**Re: Appeal of Planning Commission to deny proposed improvements
Kum & Go, #413
CEI Project No. 26728.0**

Subject: LSD 11-3966 (Kum and Go at Martin Luther King and Hill Avenue)

TO: Fayetteville Planning Commission
FROM: Andrew Garner, Senior Planner
Glenn Newman, Staff Engineer
THRU: Jeremy Pate, Development Services Director
DATE: ~~November 1, 2011~~ *Updated November 15, 2011*

EXHIBIT - A

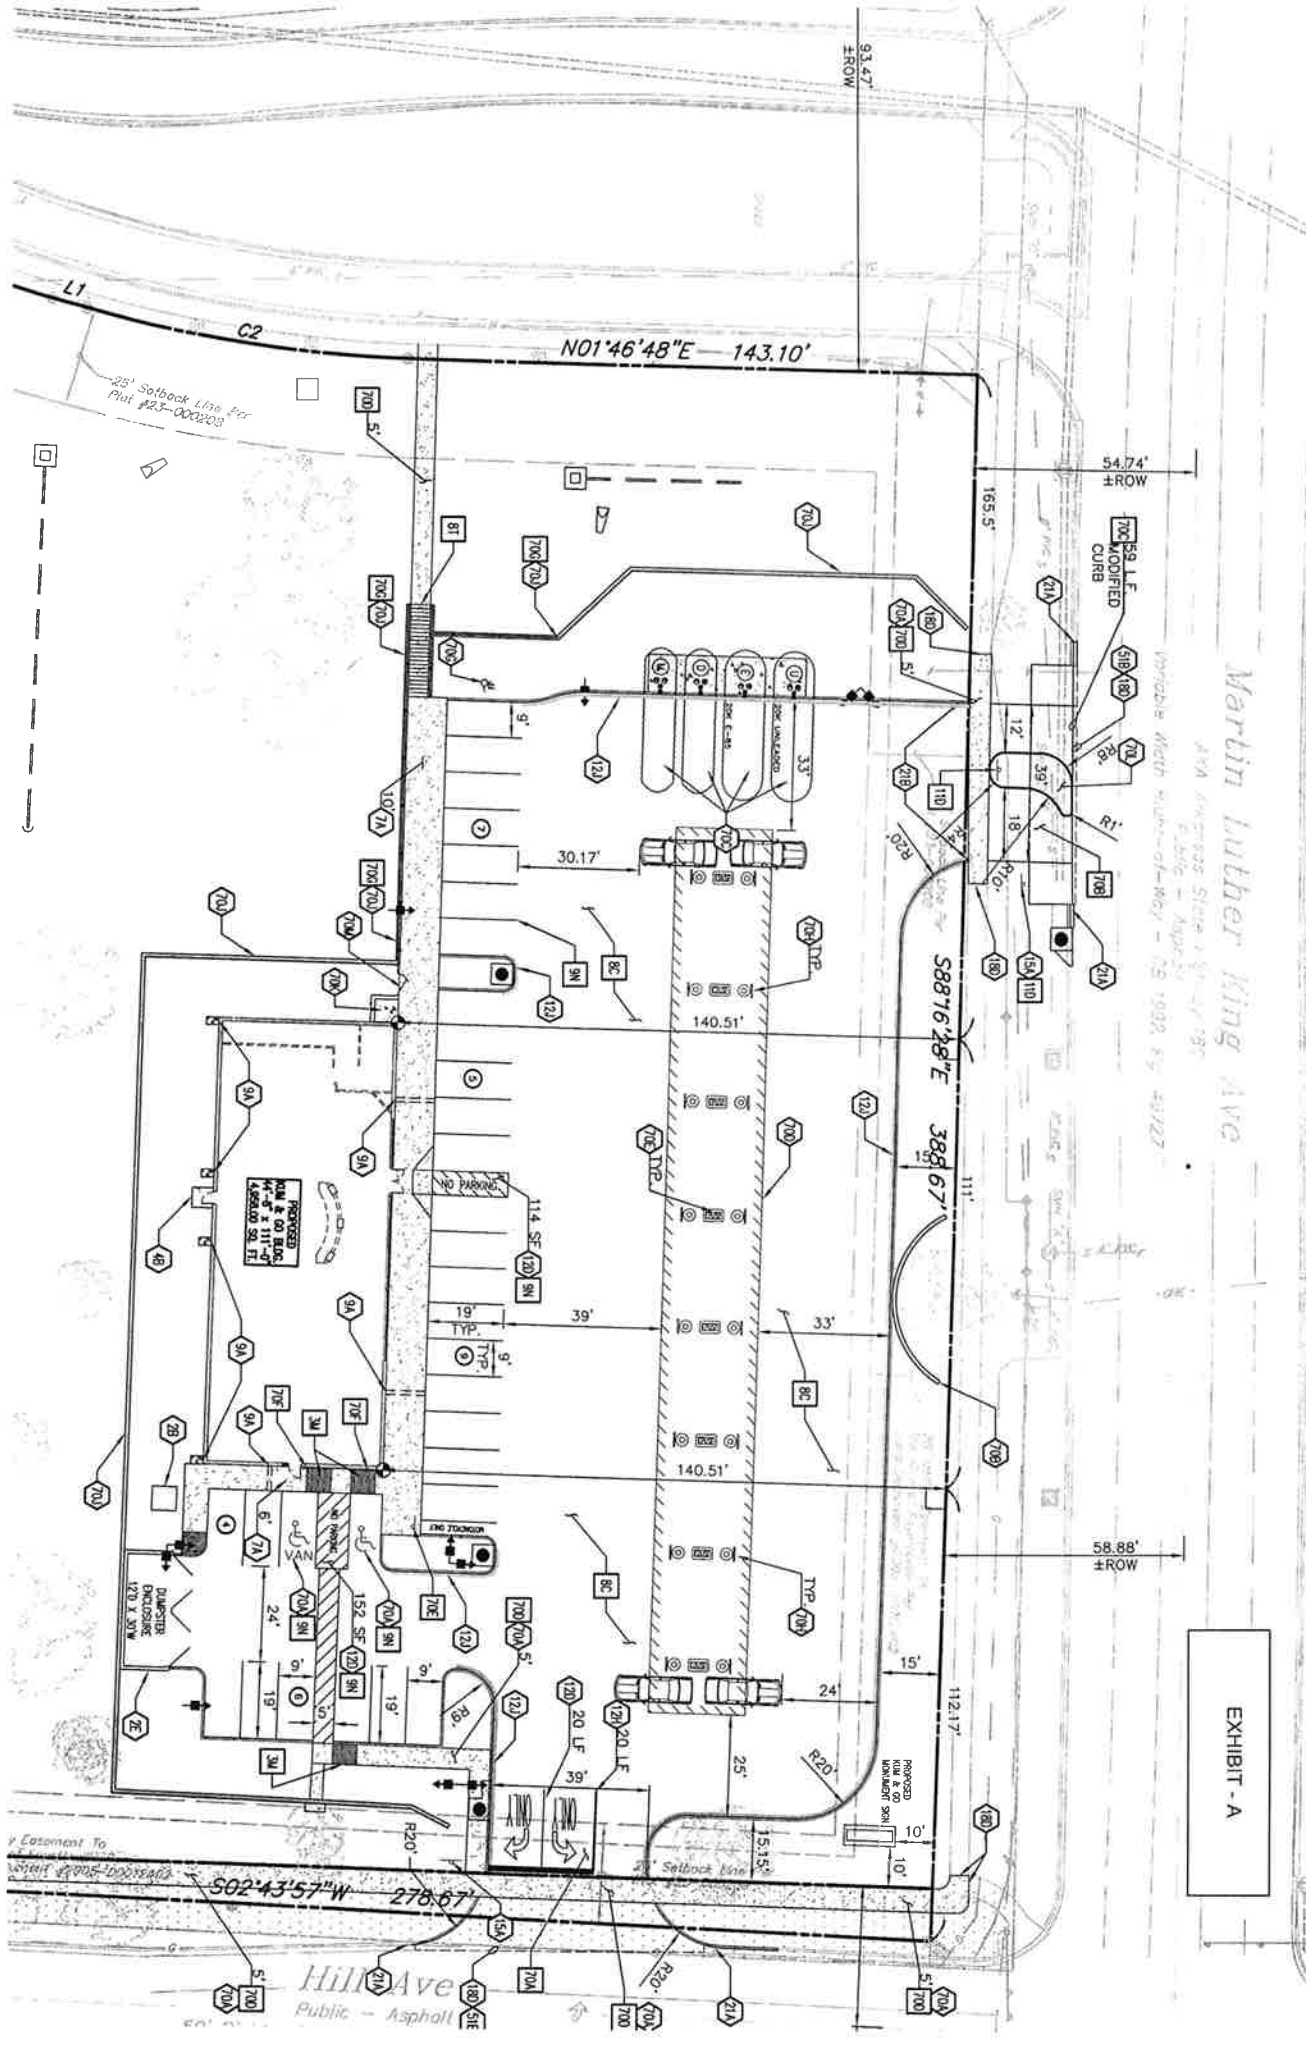
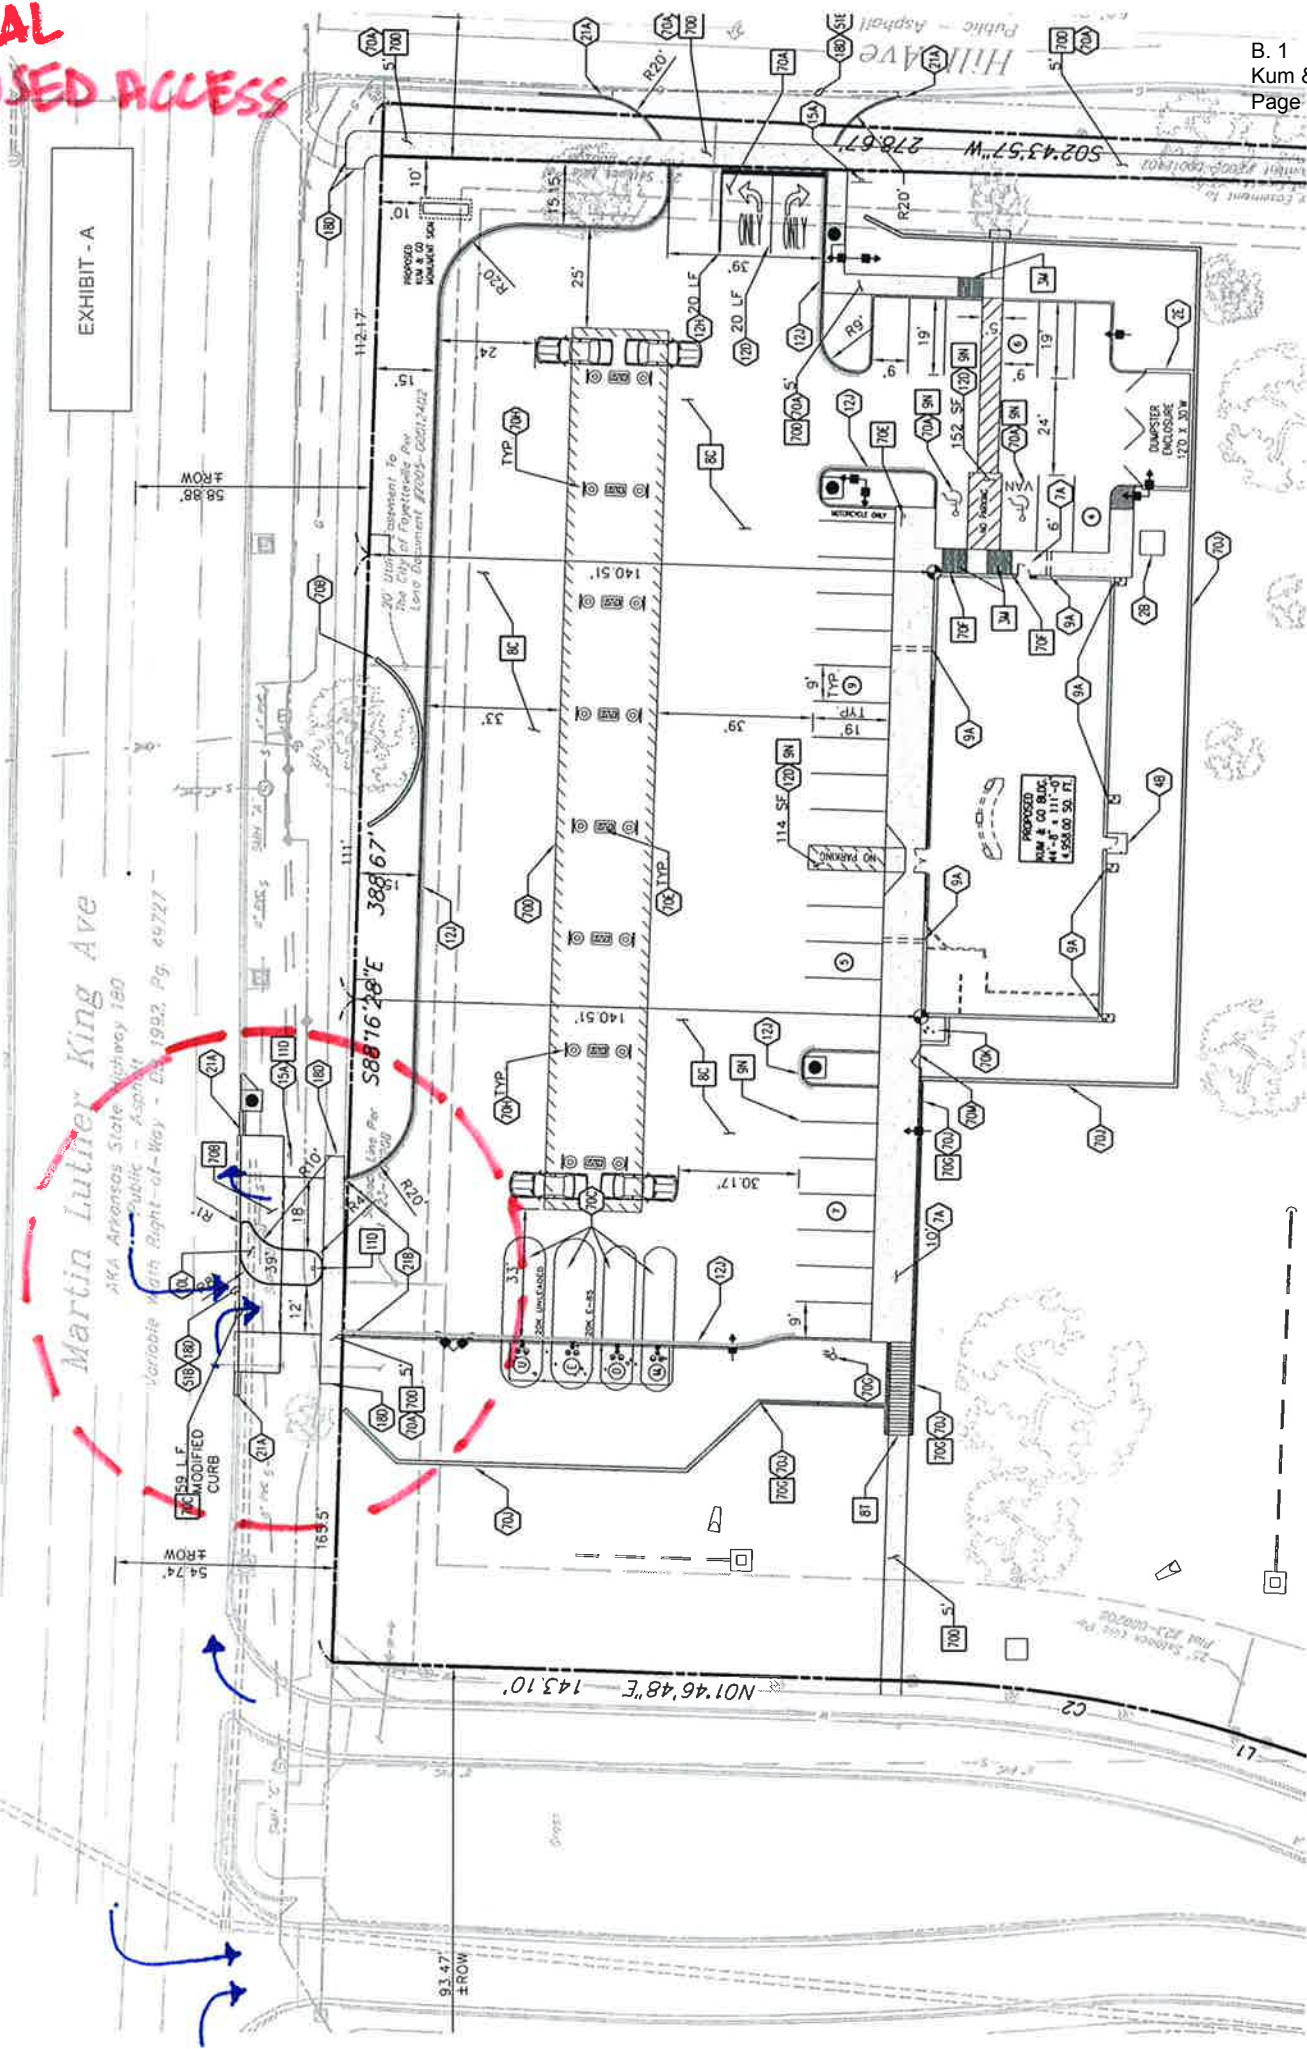
Following the Planning Commission meeting dated November 14, 2011, Kum and Go has made the following revisions to the site plan (See Exhibit – A).

- The MLK Jr. Blvd. access drive has been shifted to the west approximately 30'. This shift is to address the traffic stacking in the left turn lane along MLK Jr. Blvd. and for those vehicles wanting to proceed north onto Hill Ave.
- A pedestrian sidewalk connection has been included to extend from Royal Oak to the proposed convenience store.

Figure 1- View of proposed site and surrounding area

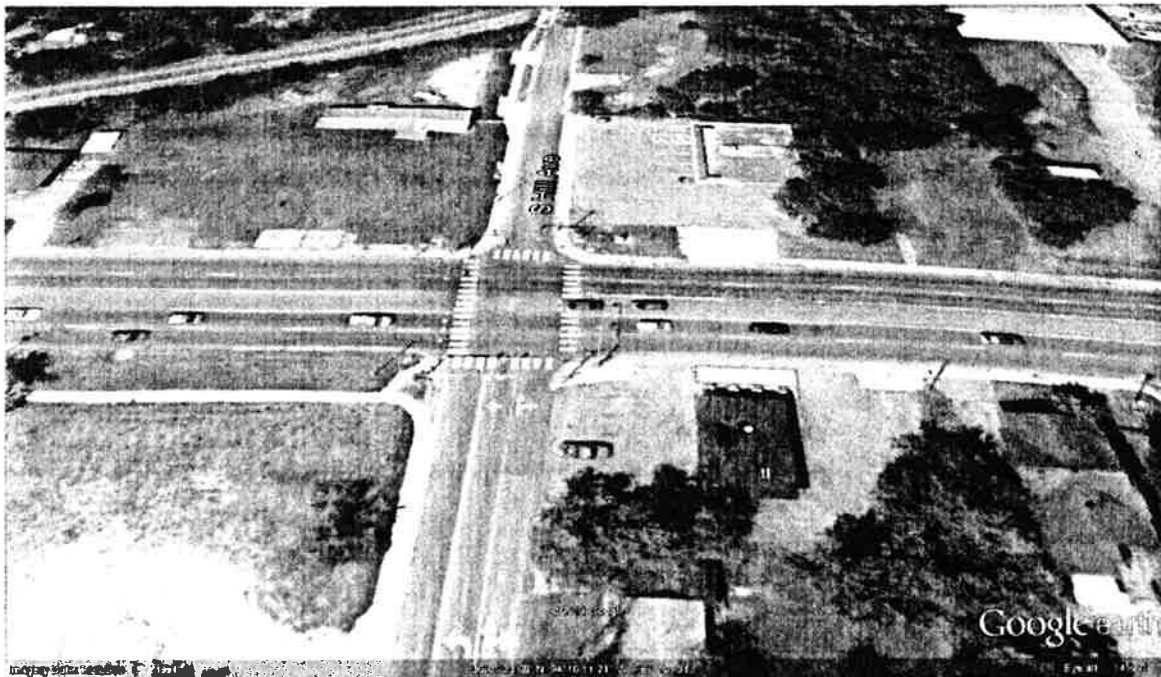
3.0 Proposed Improvement Impacts:

It is our opinion that given these above stated conditions, an unskilled driver could still potentially conflict with an eastbound left movement as stated in the City of Fayetteville Planning Commission Report.

Crosshatching of the center median lane or a mountable island in the vicinity of the Martin Luther King Boulevard entrance may also be investigated to discourage non-delivery drivers from making a left turn. See Appendix B and attached diagram. We feel that the combination of signal modifications at MLK and Hill Street combined with crosshatching of the center turn lane will allow for use of the left-in entrance on MLK without creating unsafe or excessive turning conflicts.
